# **Geotechnical Investigation**

## **Proposed Residential Development**

4386 Rideau Valley Drive  
Ottawa, Ontario

**re: Geotechnical Response to City Comments  
Proposed Residential Development  
4386 Rideau Valley Drive, Ottawa, Ontario**

# Figure 3 - Section A - Existing Conditions - Seismic Loading

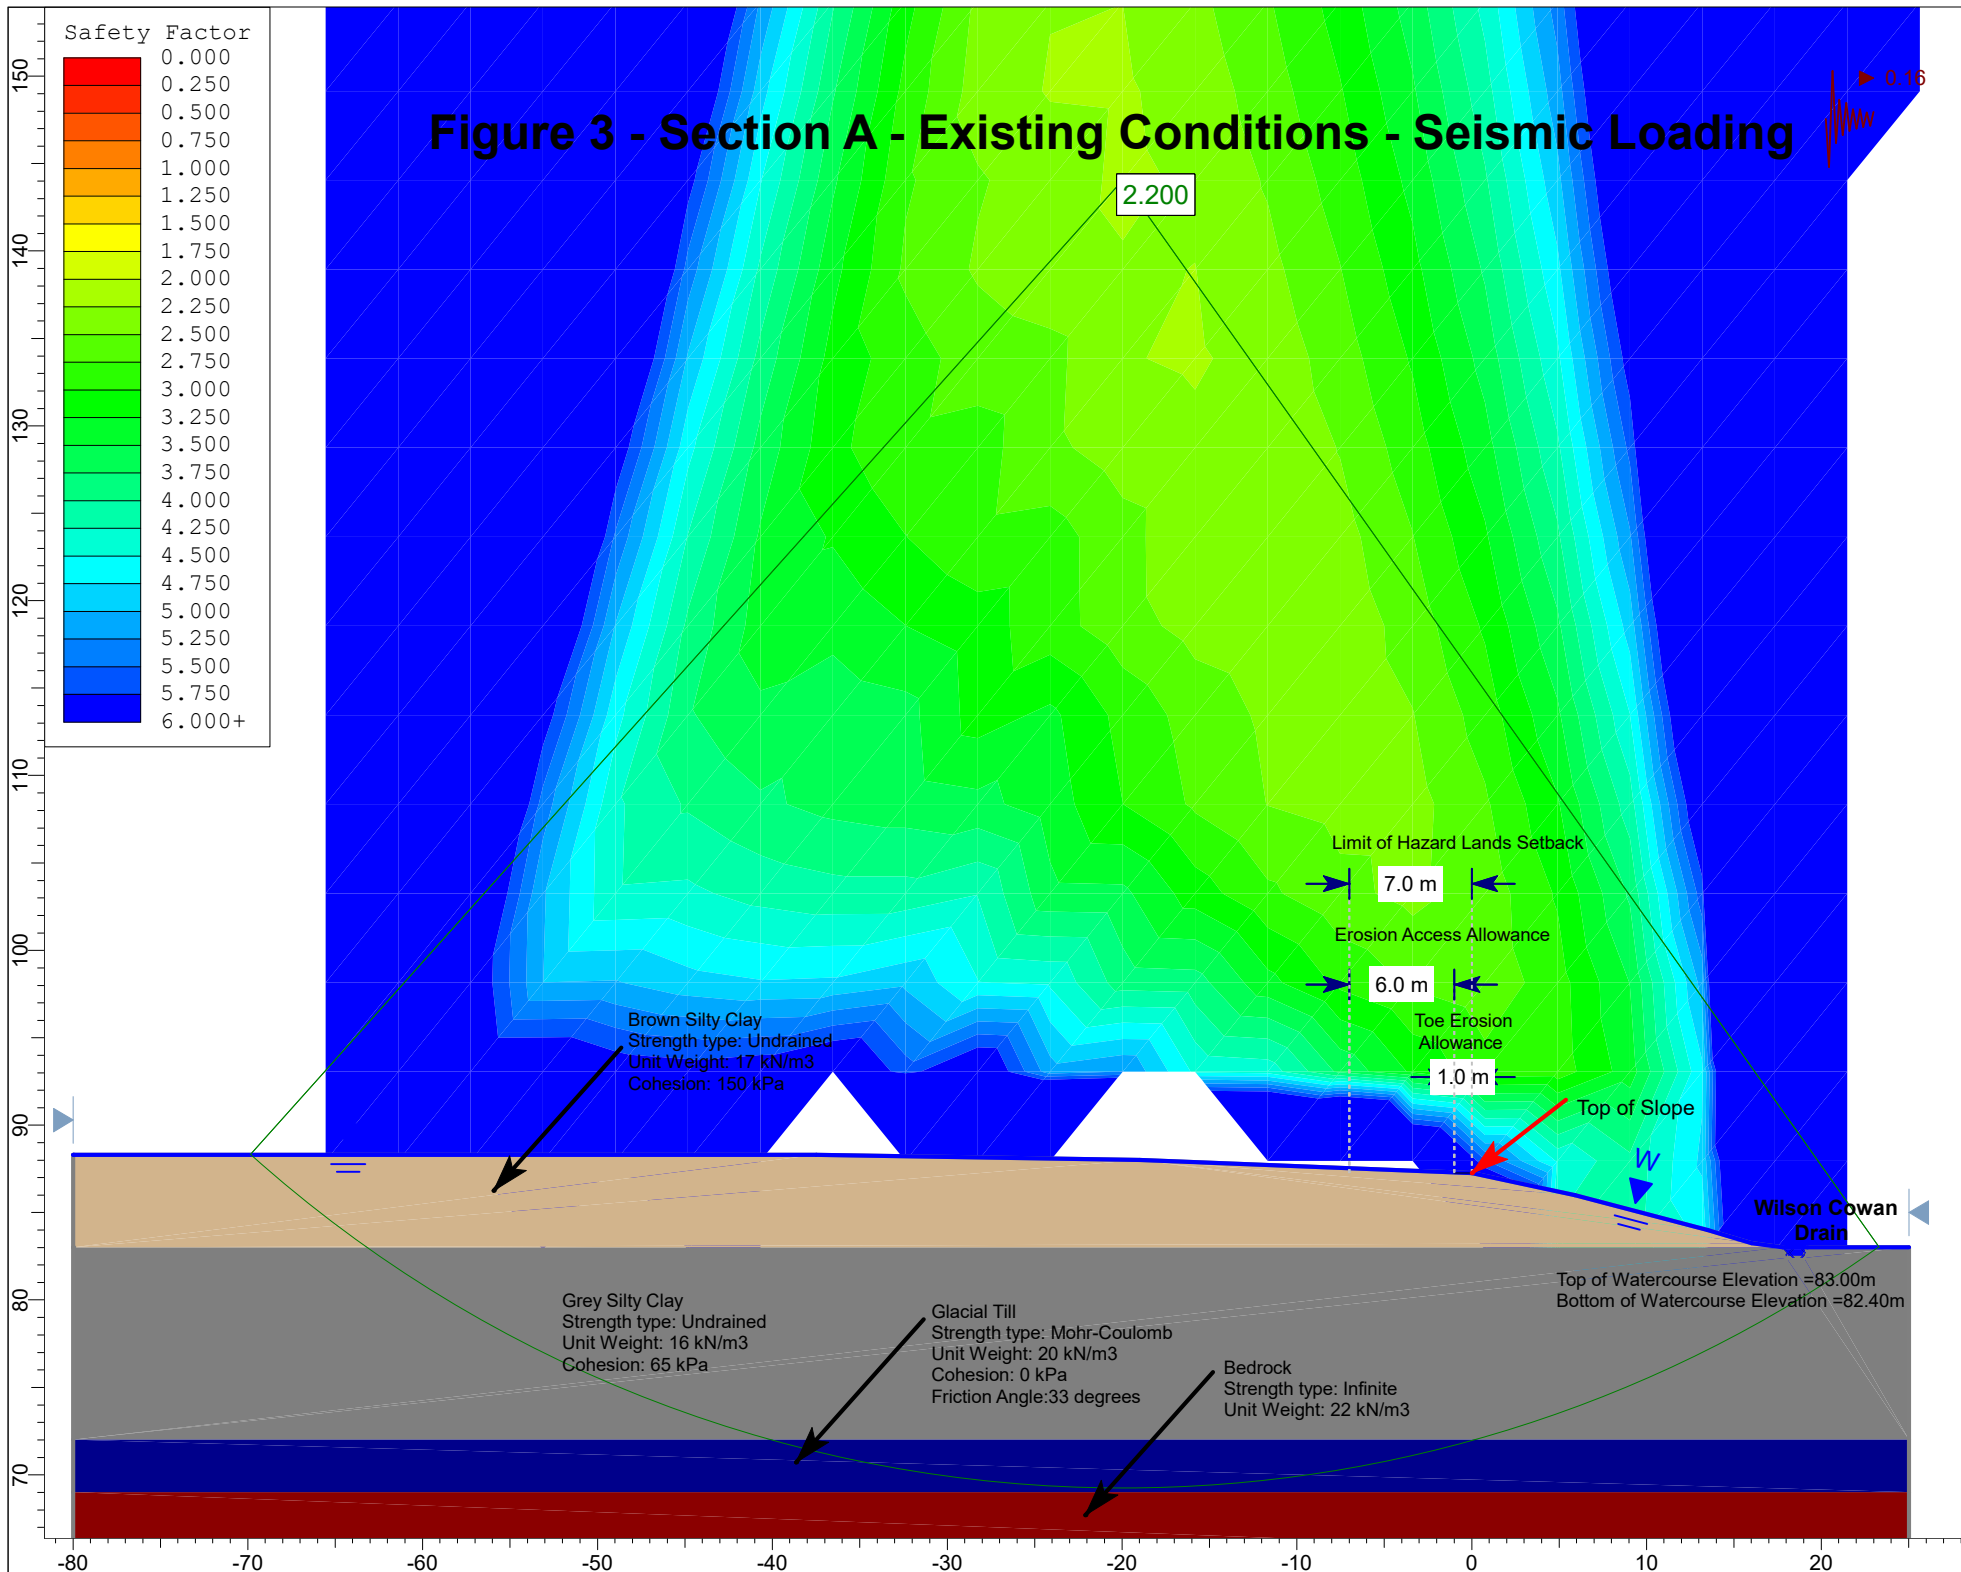
*The soil annotations on Figure 3 appear to be floating.*

Noted. The annotations for soil layers in Figure 3 have been modified in the above-mentioned revised report.

# Figure 5 - Section B - Existing Conditions - Seismic Loading

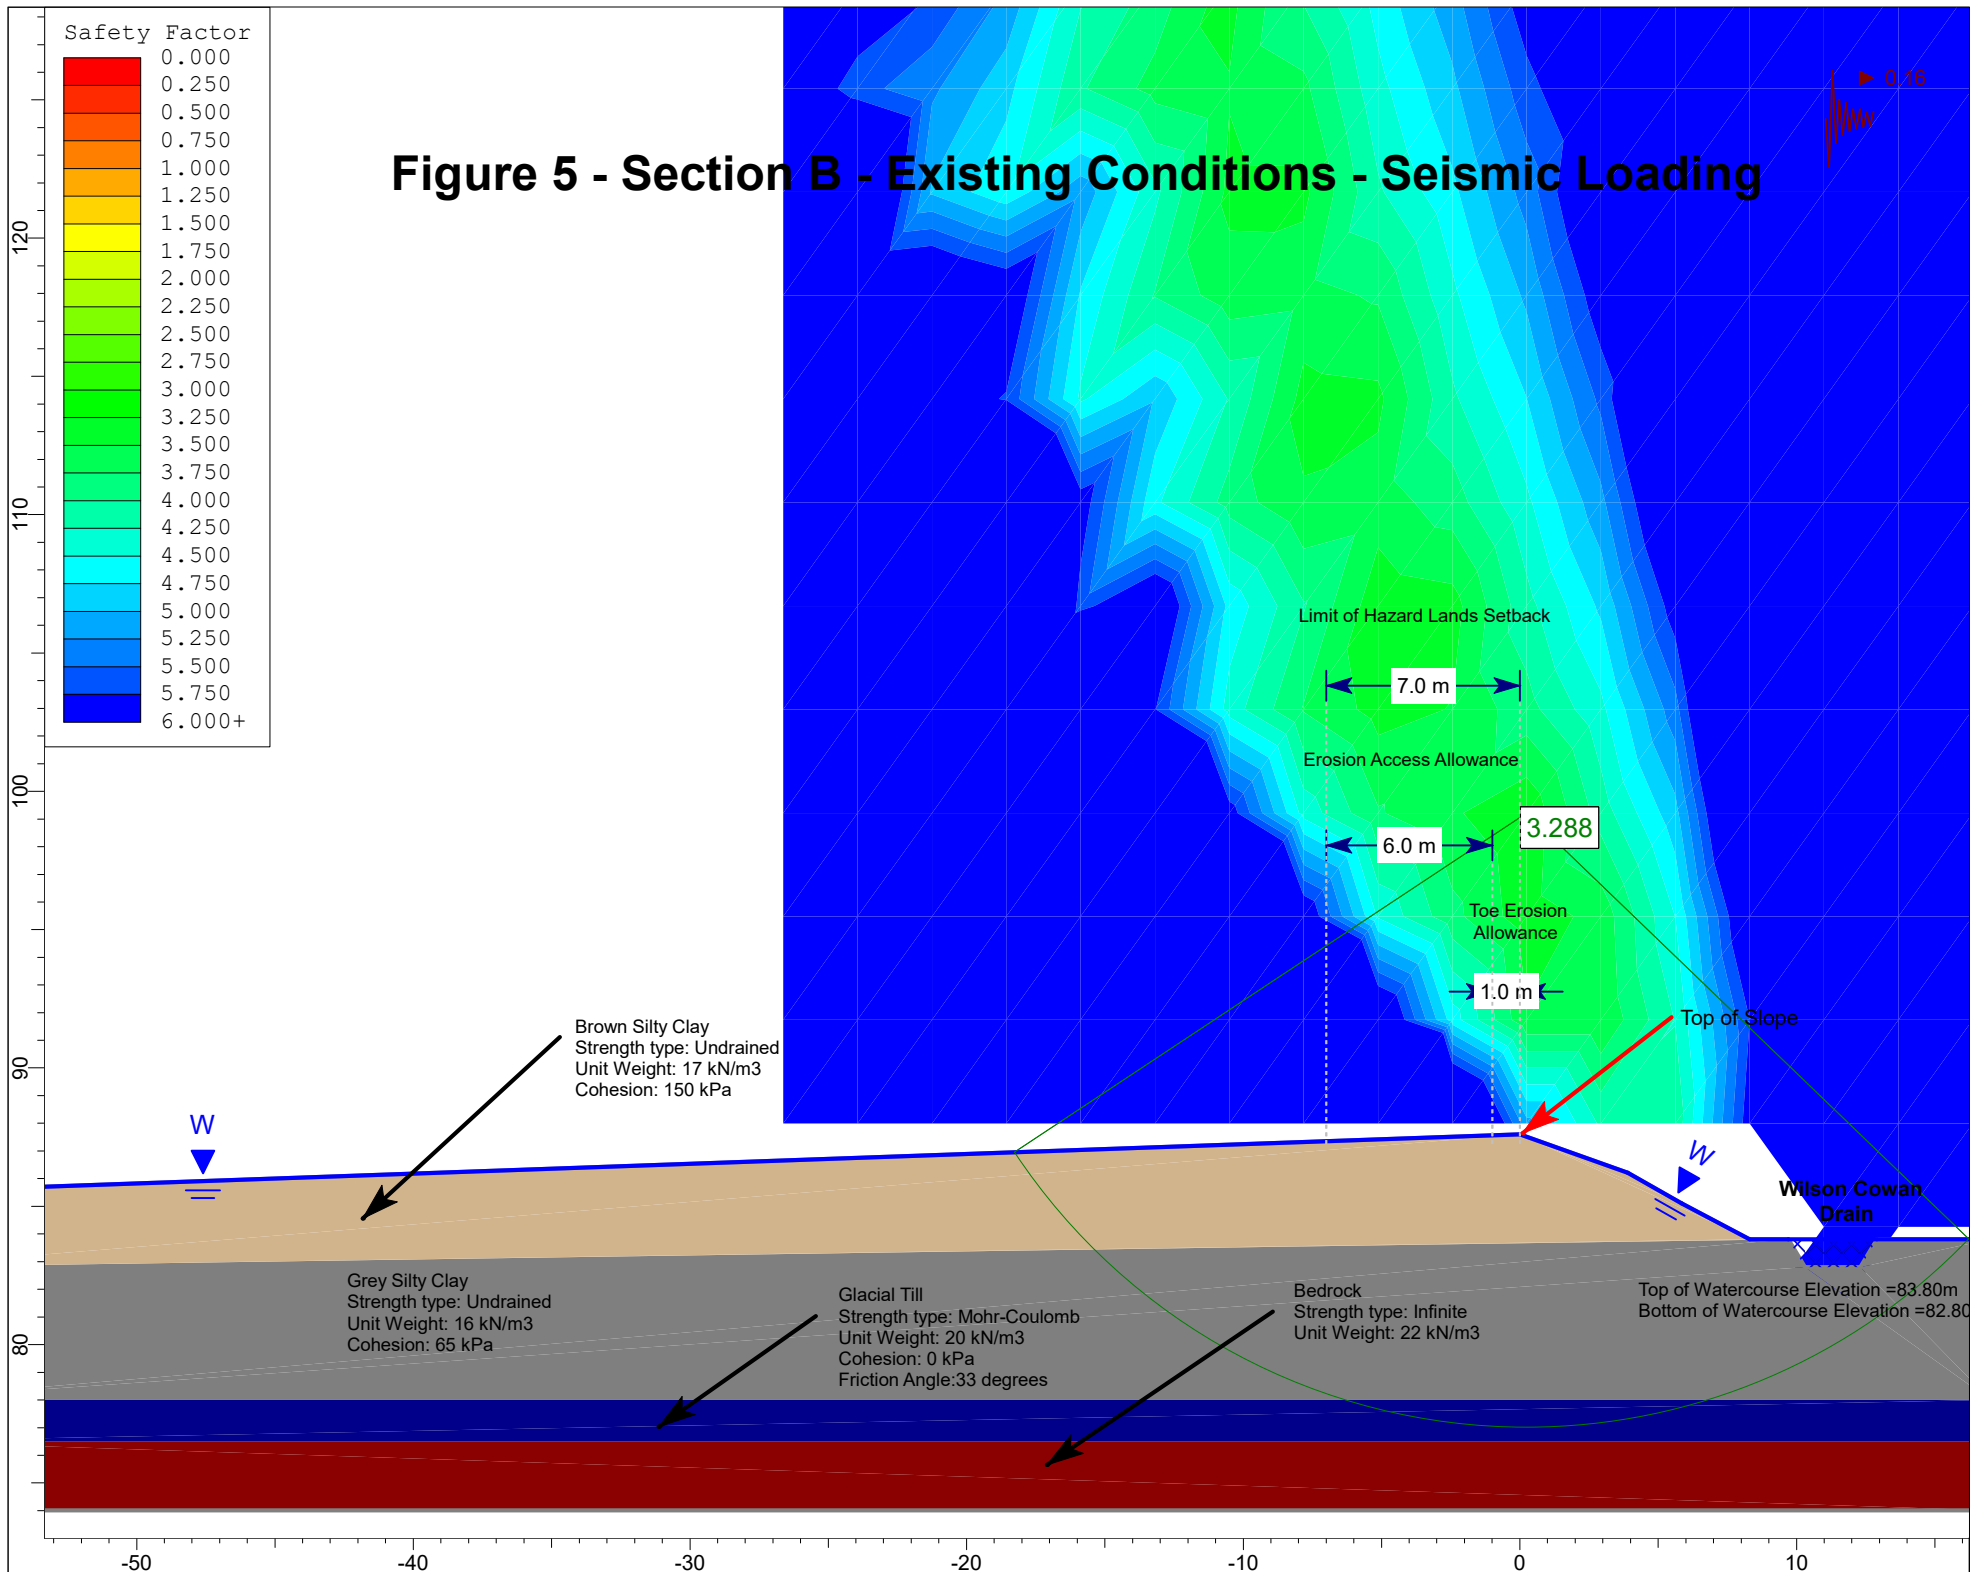
*Please include bathymetric survey data used for Figure 4 (amongst others).*

The bottom elevations of the watercourses at the studied cross sections has been determined using a high precision GPS, during our site visit to review the slope conditions. These elevations have been added to the slope cross sections included in the revised geotechnical report referenced above.
